**Boston Edison**

May 14, 1997  
BECo Ltr. 2.97.035

**Response to Request for Additional Information  
Concerning Pilgrim Station Crediting Containment Overpressure  
in the Net Positive Suction Head Analysis for the Emergency Core Cooling Pumps  
(TAC No. M97789)**

Figure 1 - Comparison of DBA-LOCA Suppression Pool Temperature Response for Different Decay Heat Inputs

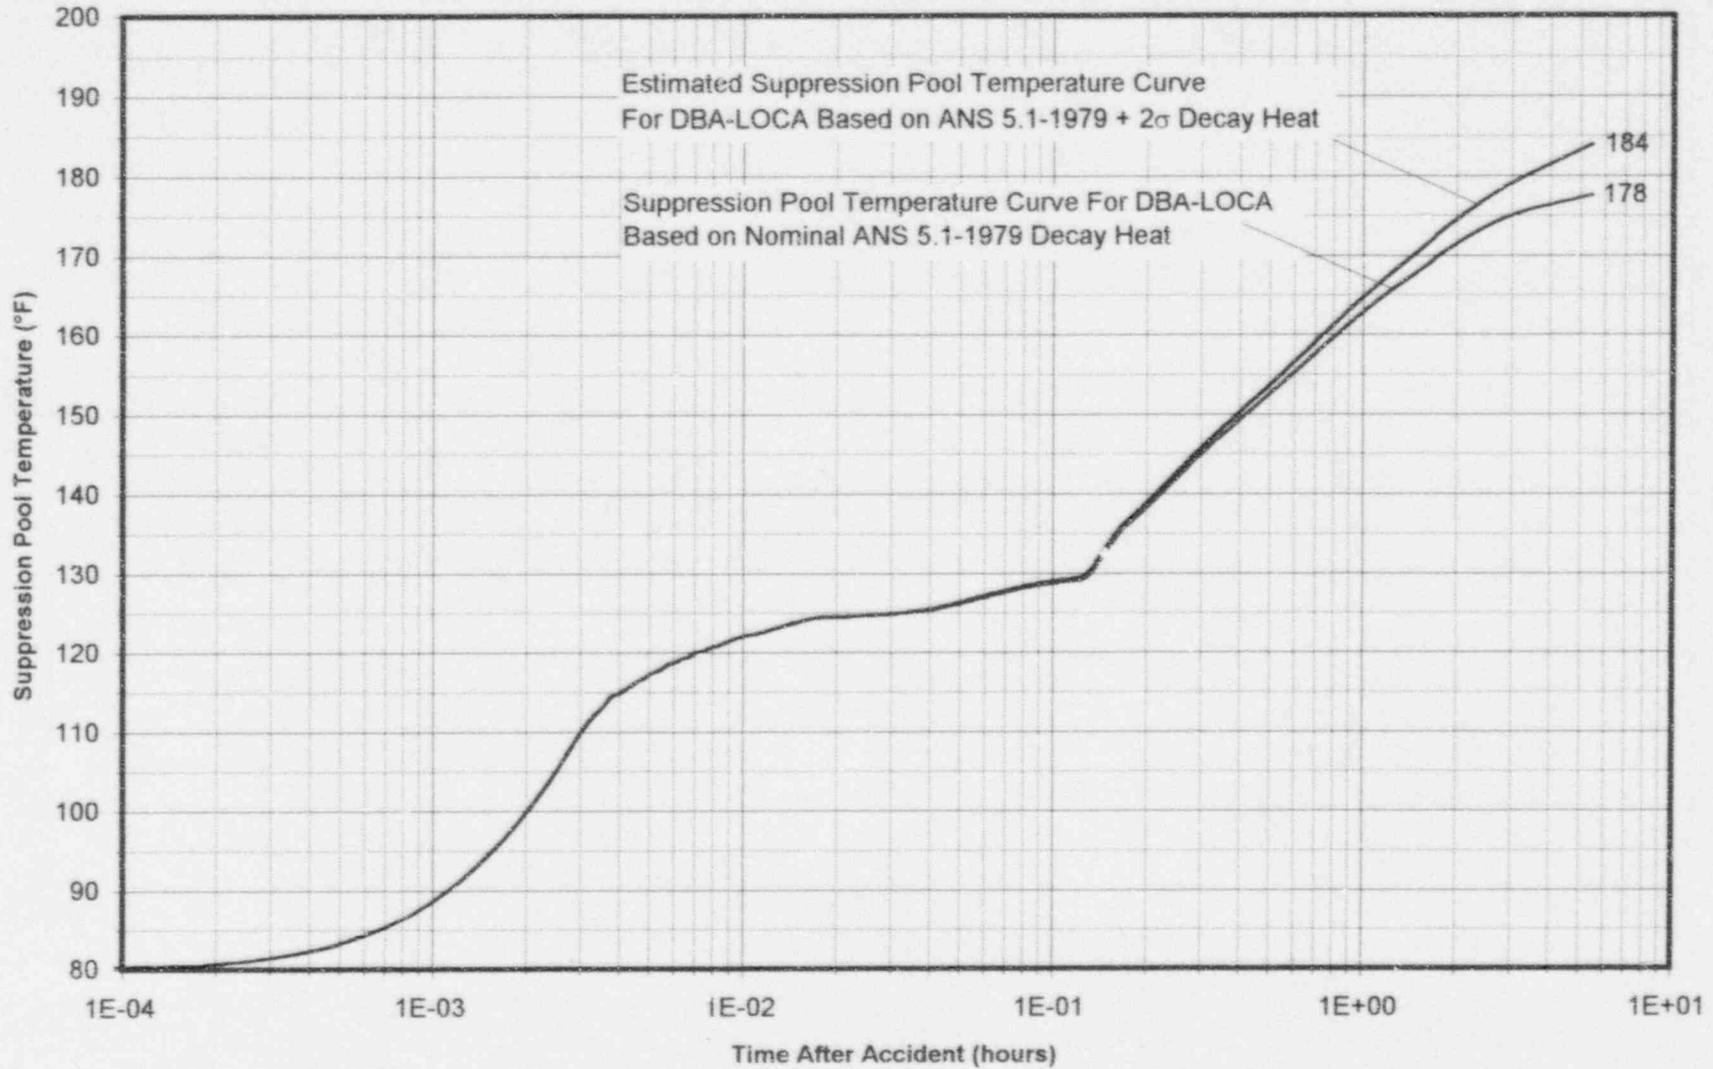
An analysis of the DBA-LOCA with  $2\sigma$  uncertainty added to the decay heat will result in a more rapid containment heatup and higher peak suppression pool temperature than resulted from the analysis discussed in SE 2983 which was based on the nominal decay heat described above. The peak suppression pool temperature resulting from the DBA-LOCA with  $2\sigma$  uncertainty added to the decay heat will be less than 185°F which is 7°F higher than the 178°F peak pool temperature resulting from analysis that used a nominal decay heat without uncertainty added. This estimate of 185°F was calculated by adding to the suppression pool temperature for the nominal decay heat case (i.e., 178°F) the temperature change resulting from the additional decay heat energy from the  $2\sigma$  uncertainty adder. That is, the additional decay heat energy due to the  $2\sigma$  adder was integrated over finite time increments and then added to the suppression pool water to increase its temperature. No accounting was made of the higher heat removal rates (due to the higher temperature across the RHR heat exchanger) that will occur between the time of containment cooling initiation and the time that the peak suppression pool temperature occurs at approximately 20,000 seconds. No accounting is made of the portion of the additional energy that will be stored elsewhere inside the containment, to be removed later in the cooldown. All of the additional energy from the  $2\sigma$  uncertainty adder between 0 to 20,000 seconds is assumed to be present in the suppression pool at 20,000 seconds, thereby, raising the suppression pool temperature to a conservative estimated maximum of 185°F. Figure 1 illustrates the pool temperature response calculated using the method described above.

Figure 2 - Comparison of Requested Pressure to Containment Pressure Available and Containment Pressure Required

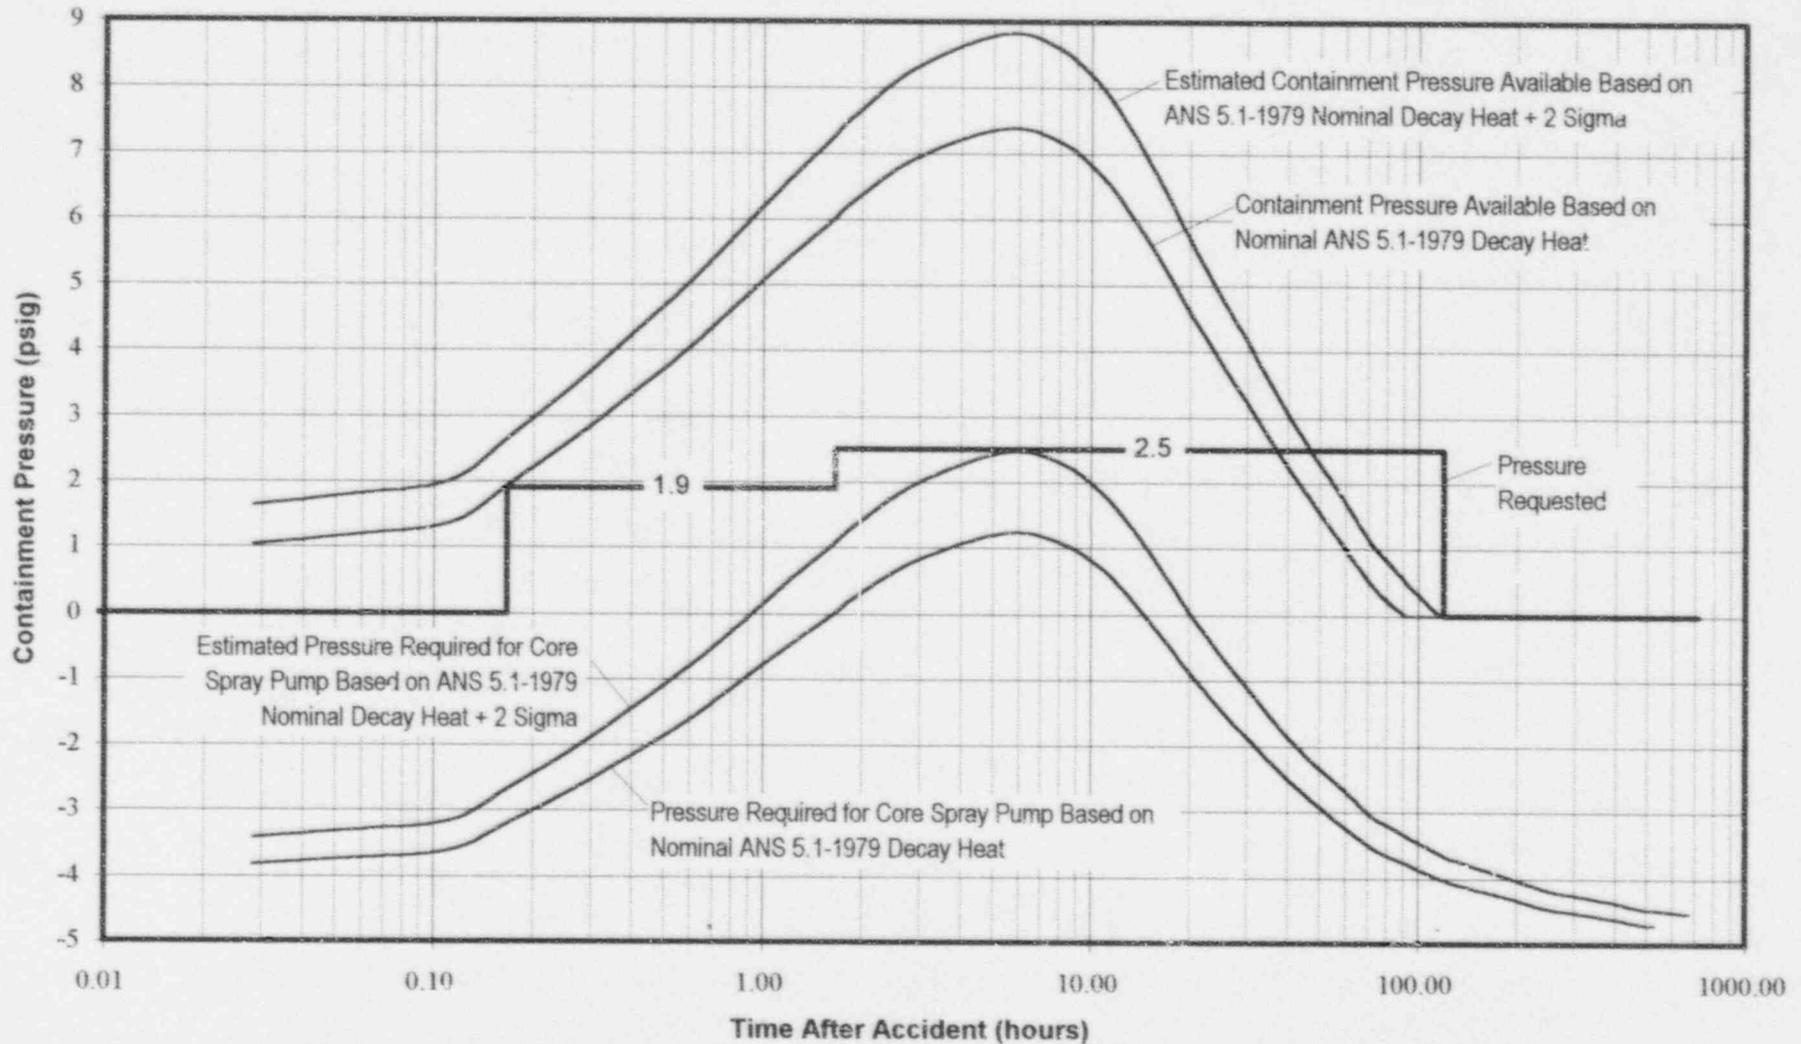
Figure 2 in this response, compares the requested values of containment pressure as a function of time against the containment pressure available assuming 5% leakage of noncondensable gas as illustrated on FSAR Figure 14.5-18. Also included on this figure is pressure required for the limiting ECCS pump(s) which is the core spray pump. However, the pressure required curve for the core spray pump is slightly higher than that shown on FSAR Figure 14.5-18 because the suction line loss was increased by 2 feet to accommodate IST measurement variations, and the pressure required to compensate for debris related head loss of .01 feet was included. As the figure illustrates, the pressure requested is less than that which will be available and greater than that which will be required.

Also included on Figure 2 is the estimated containment pressure available based on the ANS 5.1-1979 decay heat plus a 2 sigma uncertainty adder. The peak pressure available corresponds to the peak suppression pool temperature discussed previously in this response of 185°F. The estimated peak pressure required of 2.46 psig also corresponds with the estimated peak suppression pool temperature of 185°F.

Note: Curves are based on a 75°F ultimate heat sink temperature, and pressure required curves include a 2 foot additional suction line loss to accommodate IST measurement variation, and a 0.01 foot debris related head loss.

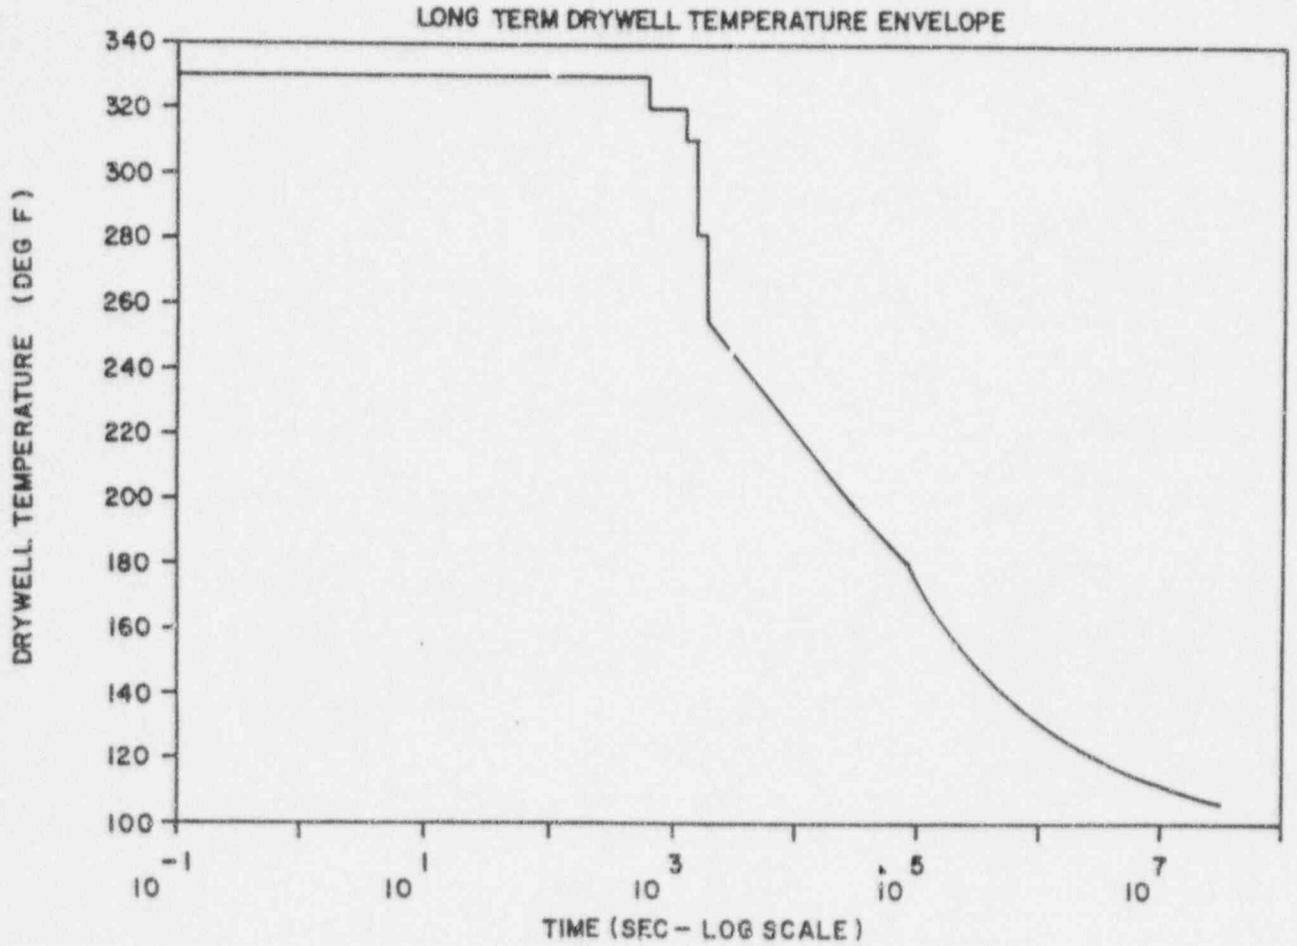
*Wyle Report No. 47066-PEN-1.1, Qualification Verification Report on General Electric Electrical Penetrations No. 238X600NLG1 for use in Pilgrim 1 Nuclear Power Station, Revision F, dated March 20, 1996 indicates that exposure of the penetration epoxy to radiation will cause weight loss (i.e., aging). From information presented in the EQ documentation package, it is not clear how aging due to radiation effects has been addressed and combined with aging due to thermal effects to demonstrate qualification of the penetration. Provide clarification.*

The impact of radiation aging on the penetration epoxy was addressed in Wyle Report 47066-PEN-1.1 Rev. F. Some loss of life (< 25%) due to radiation was thought to be acceptable based on the relative insensitivity of the epoxy to the drywell temperature (424 years at 150°F). Once it was identified the activation energy used to calculate expected life of the epoxy in Rev.

Since that time, Revision G of Wyle report 47066-PEN-1.1 was issued. This revision of the penetration qualification report provides a more detailed evaluation of the impact of radiation on the penetration epoxy. Specifically the report takes credit for a sacrificial layer of epoxy that reduces the impact of Beta to a negligible level in the area of the penetration seals. The remaining radiation,  $2.85E7$  Rads gamma, is below the damage threshold level of  $1E8$  Rads established via General Electric testing. Based on this evaluation, it has been determined that it is not necessary to reduce the expected life of the penetration epoxy due to the affects of radiation.

FIGURE C.4.1-18

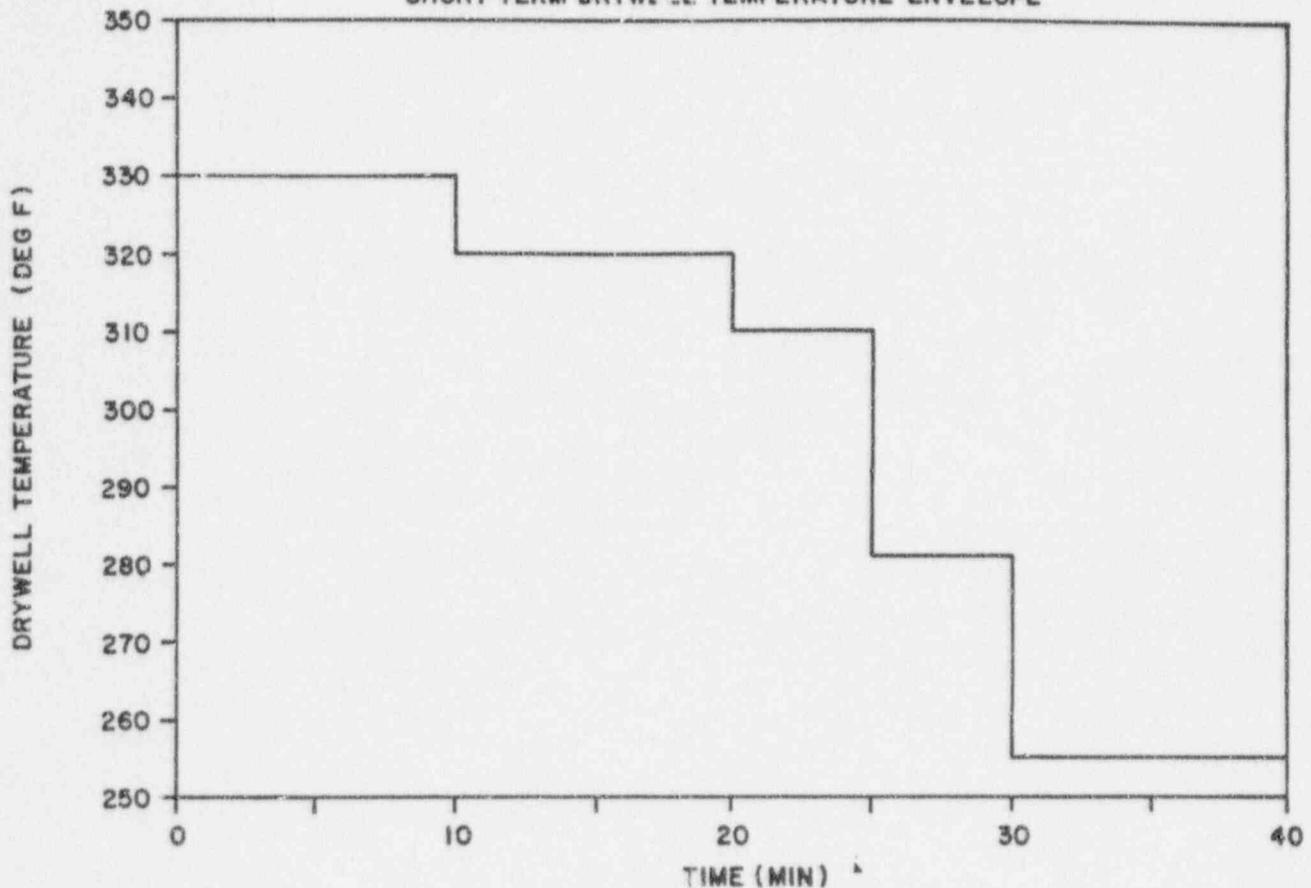
# STEAM LINE BREAK

# INSIDE CONTAINMENT

1. INDIVIDUAL MSLB TEMPERATURE PROFILES FOR VARIOUS BREAK SIZES CAN BE FOUND IN SUDDS/RF# B7-917.
2. MSLB PRESSURE PROFILE IS BOUNDED BY THE DBA LOCA PRESSURE PROFILE. SEE FIGURE C.4.1-17 & SUDDS/RF# B7-917.
3. DRYWELL TEMPERATURE ENVELOPES ARE BASED ON A 30 MINUTE OPERATOR TIME DELAY IN THE INITIATION OF DRYWELL SPRAYS.
